Access Compliance Report

Public Rights-of-Way

Intersection ID: 11357	Main Street: W_TRADE_ST	Cross Street: JOHNSON_AND_WALES_WY	Location: S
ADA ID: 32E422F82087	Ramp Type: Perp	Initial Pass/Fail: Fail	Overall Compliance: No
			Severity Score: 33.75

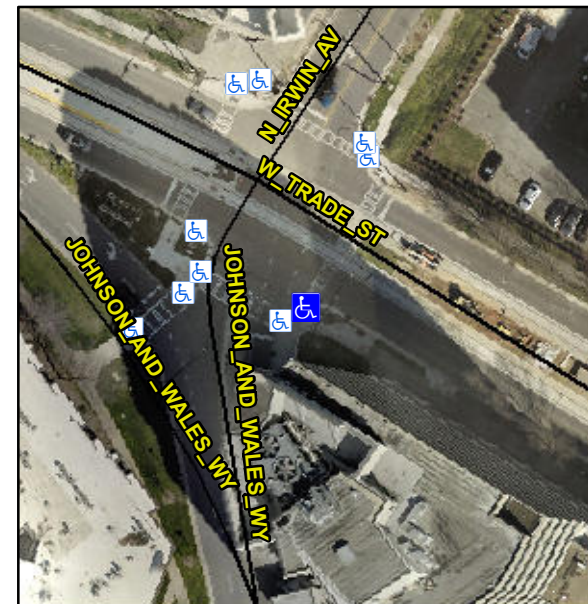
R304.5.1, R304.5.3

Compliance	Description	Data	Compliance	Description	Data
N/A	Ramp Length (in)	69.0	Yes	Ramp Slope (%)	5.2
No	Ramp Width (in)	46.0	No	Ramp XSlope (%)	9.9
N/A	Flare Type LT	N/A	N/A	Flare Type RT	N/A
N/A	Flare Slope LT (%)	N/A	N/A	Flare Slope RT (%)	N/A
N/A	Flare Traversable LT?	N/A	N/A	Flare Traversable RT?	N/A
N/A	Landing Length (in)	N/A	N/A	DWS Provided?	N/A
N/A	Landing Width (in)	N/A	N/A	DWS Contrast?	N/A
N/A	Landing Slope (%)	N/A	N/A	DWS Length (in)	N/A
N/A	Landing X Slope (%)	N/A	N/A	DWS Full Width?	N/A
N/A	Landing Curb? (Y/N)	N/A	N/A	DWS Offset (in)	N/A
N/A	Shared Landing?	N/A			
N/A	Gutter Ponding?	N/A	N/A	Gutter Slope (%)	N/A
N/A	Gutter Lip Ht (in)	N/A	N/A	Gutter X Slope (%)	N/A
N/A	Painted X Walk1?	Yes	N/A	Painted X Walk2?	N/A
	X Walk 1 Direction	To NE		X Walk 2 Direction	N/A
N/A	X Walk 1 Width (in)	62.0	N/A	X Walk 2 Width (in)	N/A
	X Walk 1 Slope (%)	3.5		X Walk 2 Slope (%)	N/A
	X Walk 1 X Slope (%)	4.6		X Walk 2 X Slope (%)	N/A

Remove & Replace Entire Ramp.
